## **SECOND FINAL NOTICE**

**DATE: MARCH 11, 2016**  
**TO: BLUE BIRD OWNERS**  
**SUBJECT: RECALL R15YC**  
**C E WHITE QUASI-STATIC GUSSET FASTENERS**

**IMPORTANT SAFETY RECALL NOTICE**

**NHTSA Recall Number 15V136 School Bus**

Figure 1

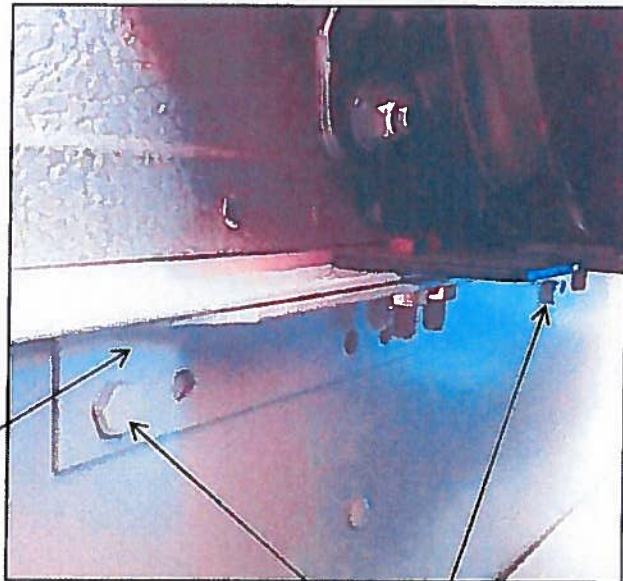
Locate the seat gusset reinforcement bracket for each Quasi-Static, 3-point seat. It will be fastened to the wall, immediately below the seat ledge, with at least two (2) grade 8 bolts. Visually check the bolts for six (6) dashed markings on the head of each bolt as referenced in Figure 1. If these markings are not present or there are other markings, perform the remaining instructions.

Inspect the seat mounting fasteners securing the gusset reinforcement to the wall. If a fastener is incorrect, install additional seat gusset reinforcement bracket.

Figure 2

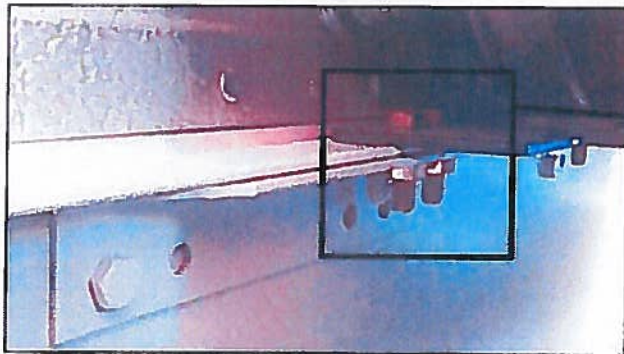
Remove and retain two bolts and nuts

1. Remove and retain the two rear most mounting fasteners attaching the seat to the gusset. Reference Figure 2 for location of the two fasteners.
2. Place the new reinforcement bracket (10041875) into position and reinstall the two fasteners. Reference Figure 3 and Figure 4 for bracket location. Tighten fasteners snugly but do not torque.
3. Using a 25/64" drill bit (obtain locally), locate the rear hole on reinforcement bracket 10041875. Using this hole as a guide, drill thru the gusset and lower seat gusset reinforcement bracket.
4. Clean away metal shavings and install new 3/8" capscrew (00803213) and nut (02171809). Reference Figure 4 for an installed reinforcement bracket.
5. Torque new 3/8" nut (02171809) to 29-33 ft. lbs.
6. Torque two (2) existing 5/16" nut(s) to 12-13 ft. lbs.

Photo # 1

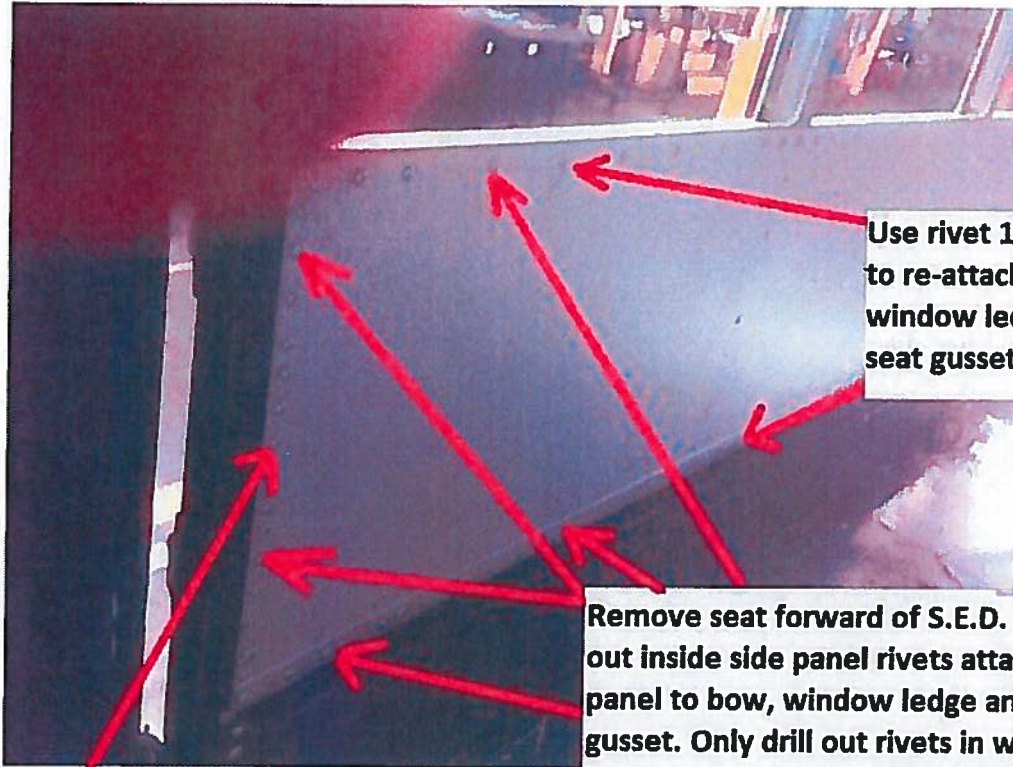
- Remove passenger seat just forward of S.E.D.
- Remove passenger window retainer screw/washer at S.E.D.
- Drill out inside side panel attaching rivets at door, window ledge and seat gusset (see Photo # 1).

Remove seat forward of S.E.D. Drill out inside side panel rivets attaching panel to bow, window ledge and seat gusset. Only drill out rivets in window ledge and seat gusset 12"-18" forward of S.E.D. Peel back inside panel to gain access to back side of seat gusset.

- Torque 3/8 bolts to 29-33 ft. lbs.
- Clean old adhesive from inside side panel, window ledge, seat gusset and apply Magnobond adhesive (10016411) to panel and reinstall with correct rivets per photo # 1 instruction. **No adhesive required at panel to S.E.D. bow vertical joint.**

Use rivet 10034534 to re-attach panel at window ledge and seat gusset.

Use rivet 01549211 to re-attach panel to S.E.D. bow.

Photo # 2

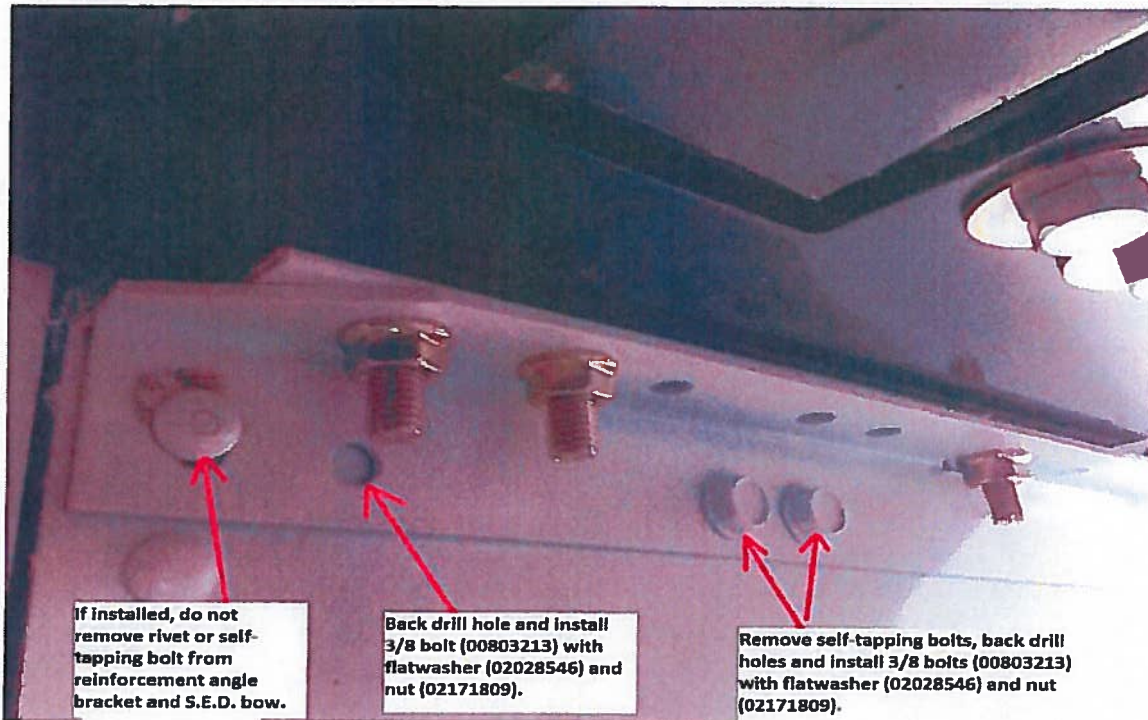
- Remove self-tapping bolts in seat reinforcement angle. **If one of the 3 self-tapping bolts or a rivet is installed in bow, do not remove bolt or rivet (see photo # 2).**

- Back drill 3 holes and install 3/8-16 x 1 1/4" grade 8 bolts (00803213) in reinforcement angle with flat washer (02028546) and nut (02171809). Flat washer to be installed on back side of seat gusset (between interior and exterior panels).
